SPECIAL USE APPLICATION: SU-SCH 23-0586

LUHO MEETING DATE: FEBRUARY 26, 2024

Request: Special Use Permit for a School

REVISION DATE: 10/17 6	TRANSPORTATION TECHNICAL MANUAL	 Hillsborough County Florida	DRAWING NO. <b>TS-4</b> SHEET NO. 1 OF 1
------------------------------	---------------------------------------	--	---

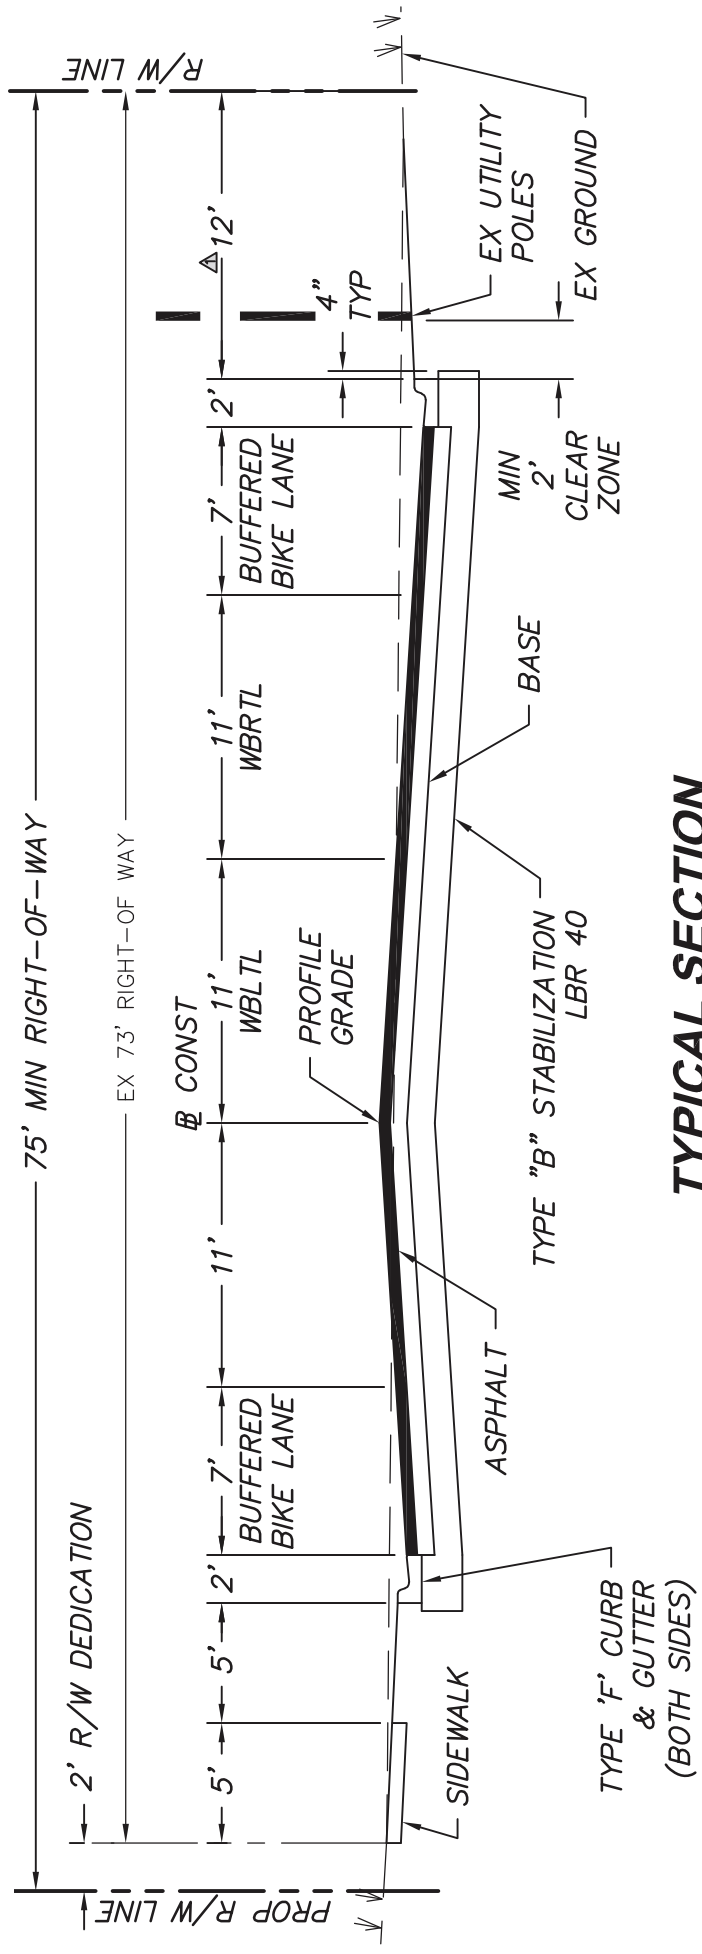
A Design Exception is requested to propose an alternative typical section to TS-4. Bishop Road has minimal pedestrian traffic, any pedestrian traffic generated should be to/from the school property. The use of a 5-foot sidewalk on the south side of the road would currently be the best option from a maintenance perspective for this developing area. As noted, Right-of-Way is to be dedicated (2 feet) in addition to the existing Right-of-Way (73 feet) to provide a total of 75 feet of Right-of Way allowing room for the future sidewalk on the north side of Bishop in the event pedestrian traffic increases from future development in the area. The proposed Bishop Road Typical Section is provided in **Exhibit C**.

PROJECT: NAVIGATOR ACADEMY OF LEADERSHIP SOUTHSHORE  
US-301 (SR-43), HILLSBOROUGH COUNTY, FL  
SHEET TITLE: TRAFFIC CIRCULATION PLAN

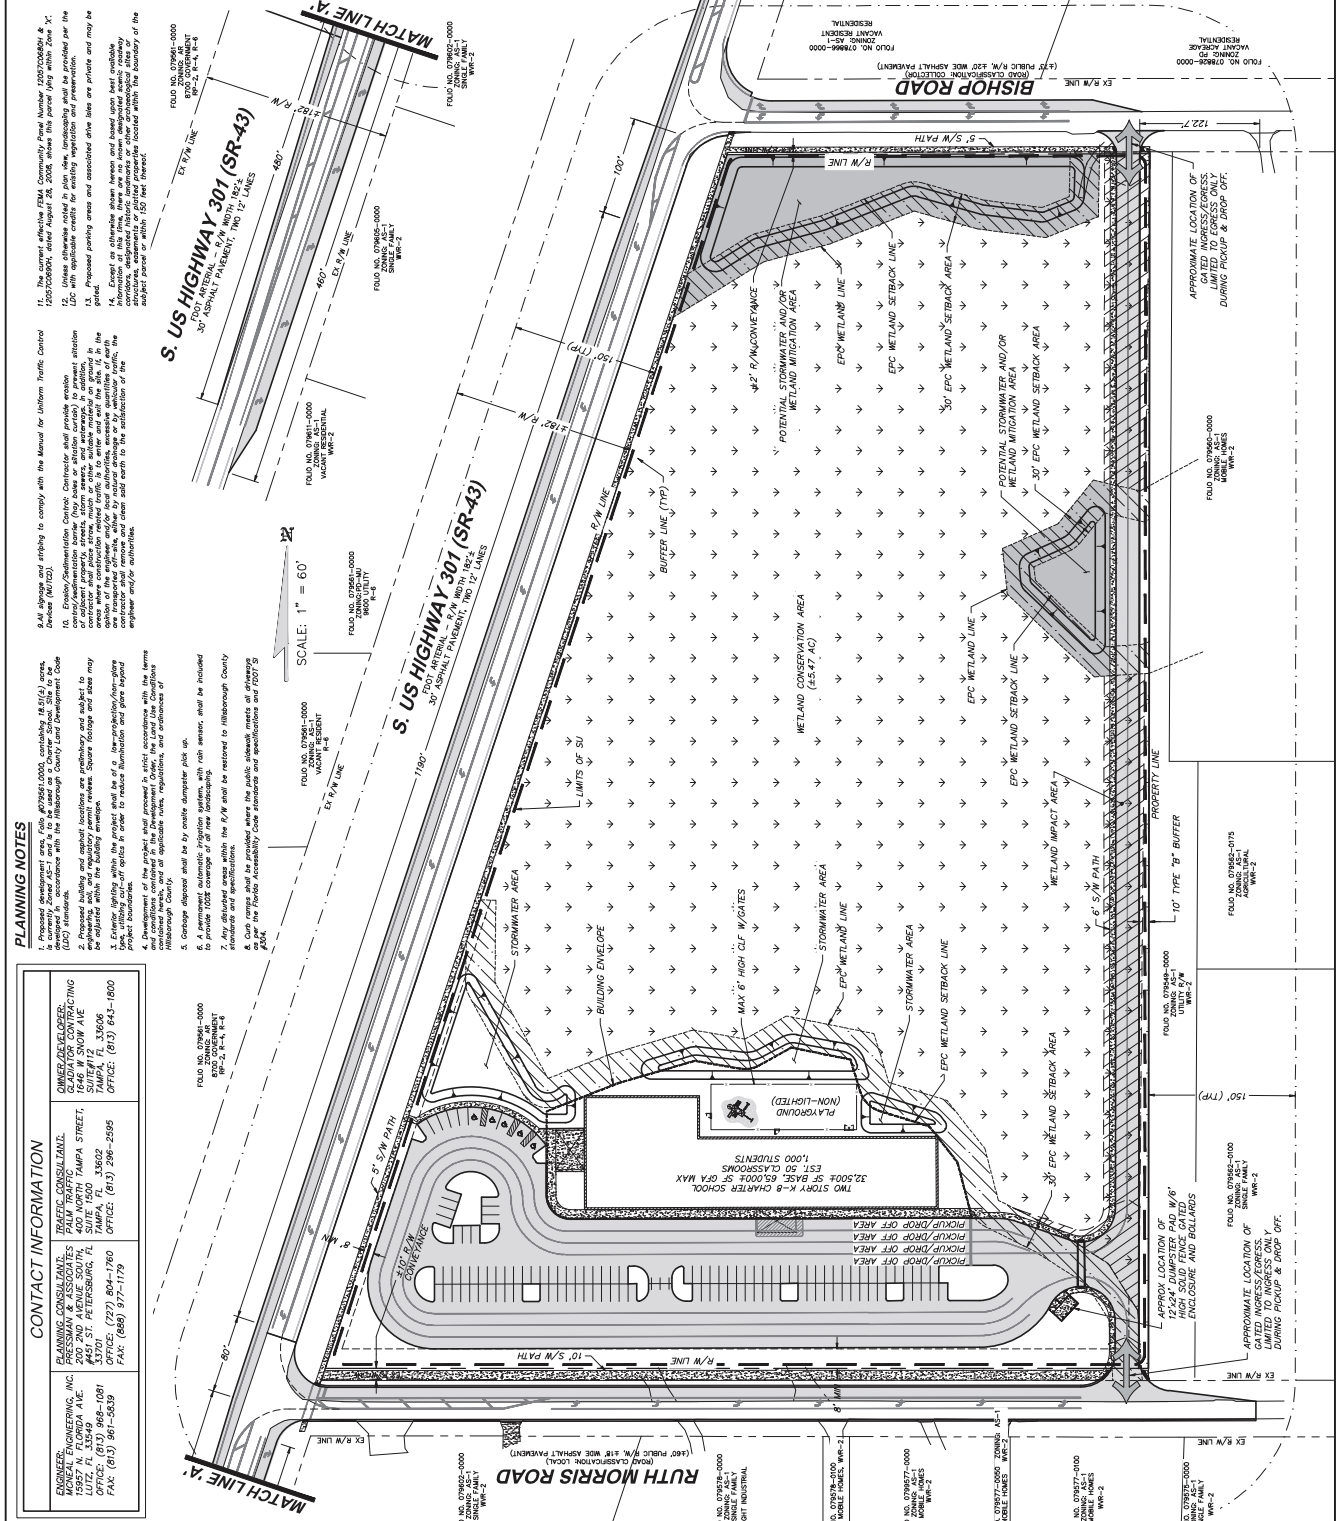
Staff has reviewed the proposed School Circulation Plans and determined that it meets the requirements of Section 6.03.13 of the Hillsborough County Land Development Code, governing vehicle circulation, queuing and parking. The proposed site layout is providing 6,125 linear feet of vehicle stacking to meet the minimum required stacking. Staff notes that student drop off and pick up traffic shall enter the site from Ruth Morris Rd. and exit the site via Bishop Rd. On an annual basis and continuing until 1 year after the private school reaches its maximum enrollment of 1,000 students, the developer will be required to assess the sufficiency of queuing both on and off-site at the project access point(s). Should deficiencies be found to exist, the school will be required to work with the Hillsborough County Public Works Dept. to identify and implement additional on or off-site corrective measures.

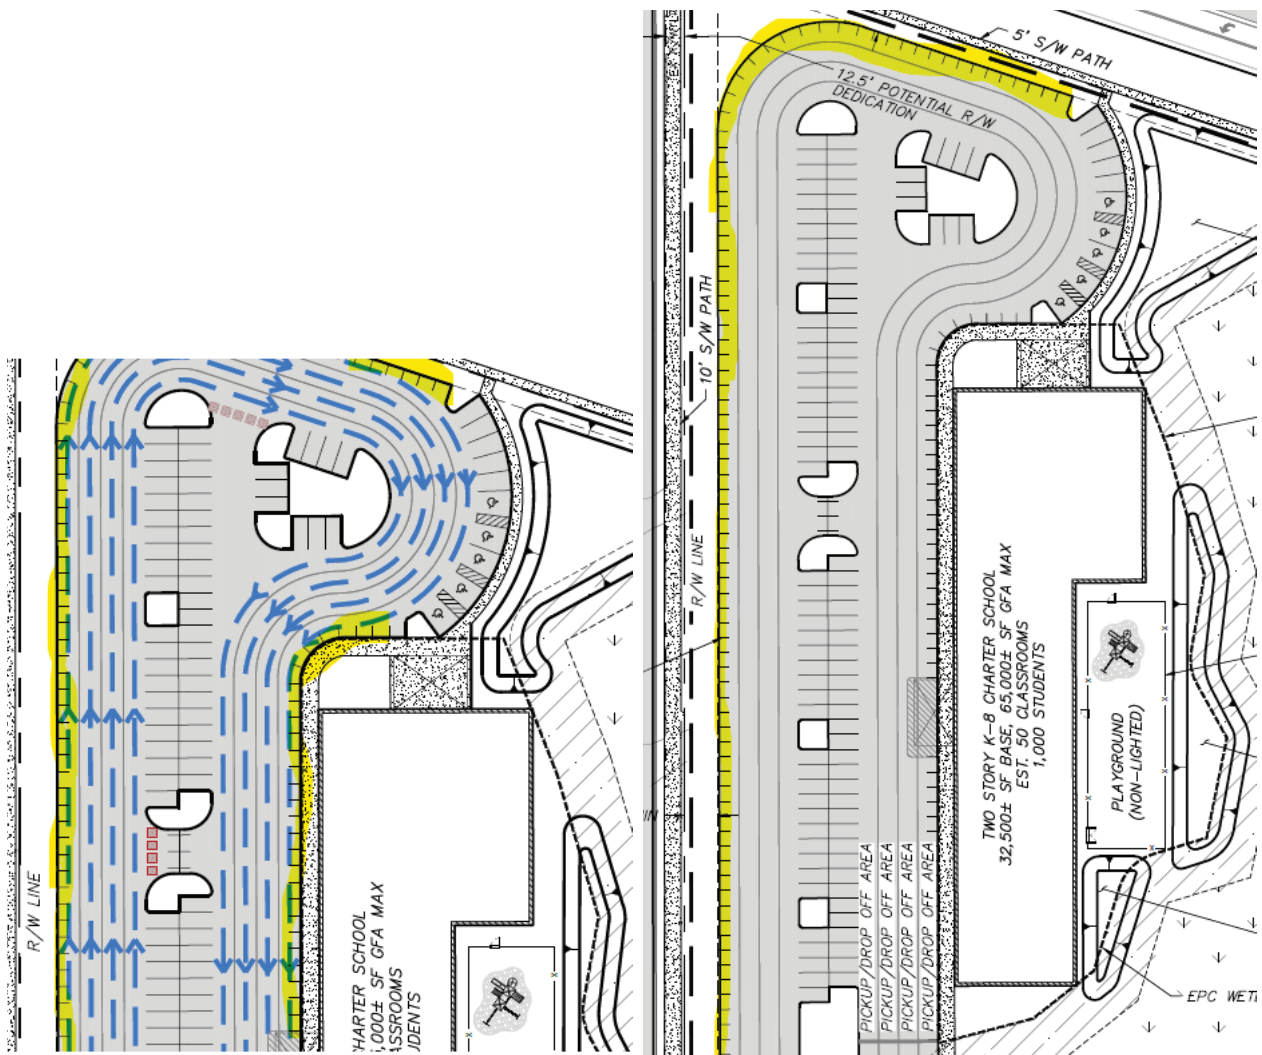
- ii. How will the exit only traffic be enforced during drop off/pick up times to prevent vehicles from entering? Consider both signage and staff traffic assistance stations.*

Response: Revised to show staff traffic assistance station.
